To: Mr. Tim Johnson, American TCB
From: David Waitt
Subject: FCC ID: O8FAOKI
IC: 3905A-AOKI

This letter addresses your compliance concerns regarding the FCC & IC application for the Palm T|X.

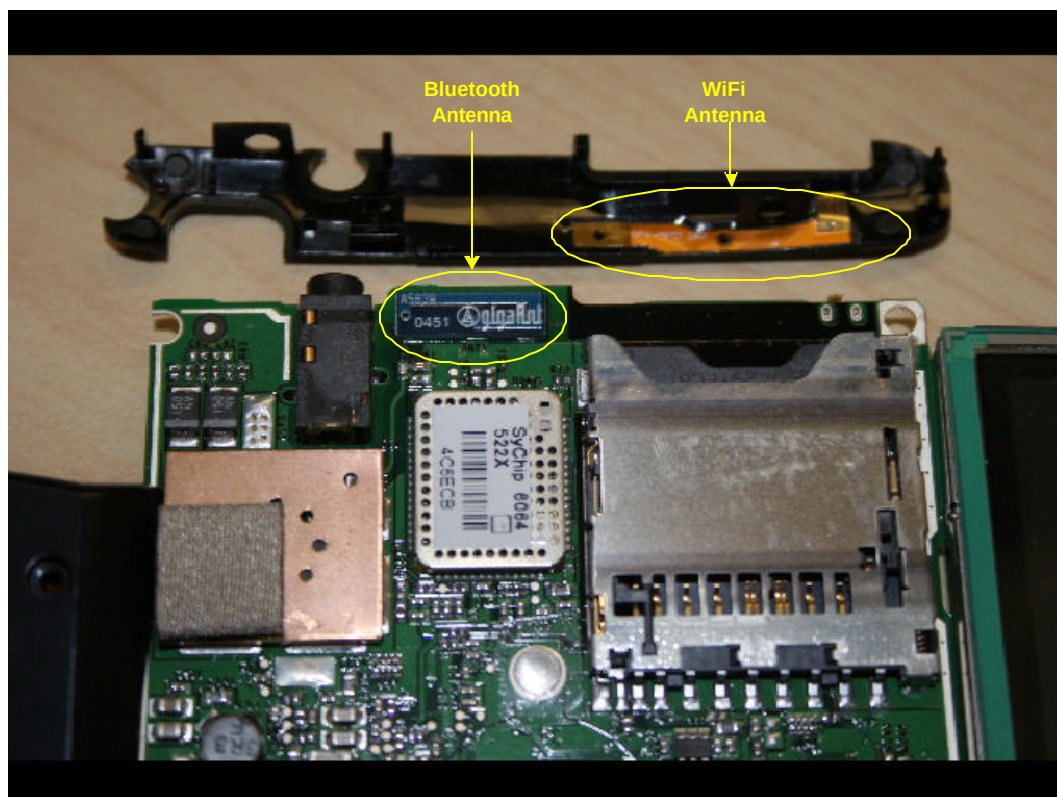
3) Photographs do not clearly show (or at least identify) both antennas, please label or show photographs as necessary to denote both antennas within this device.

Palm: See photos below.

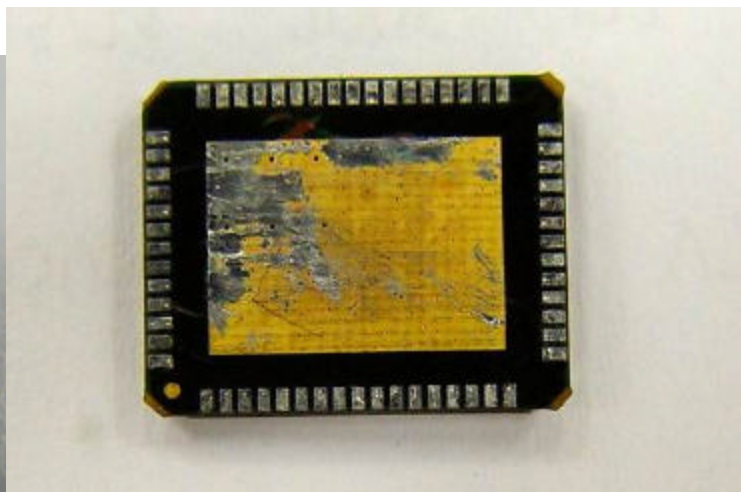
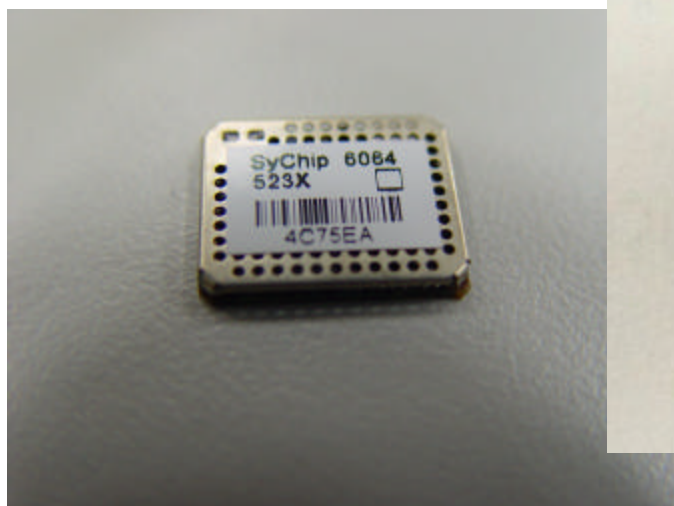
4) Even though the RF portions are a secondary module boards, bottom views of the module boards are still required. It is not necessary to destroy the sample to take these, but instead take from an uninstalled part. Please provide.

Palm: See photo below.
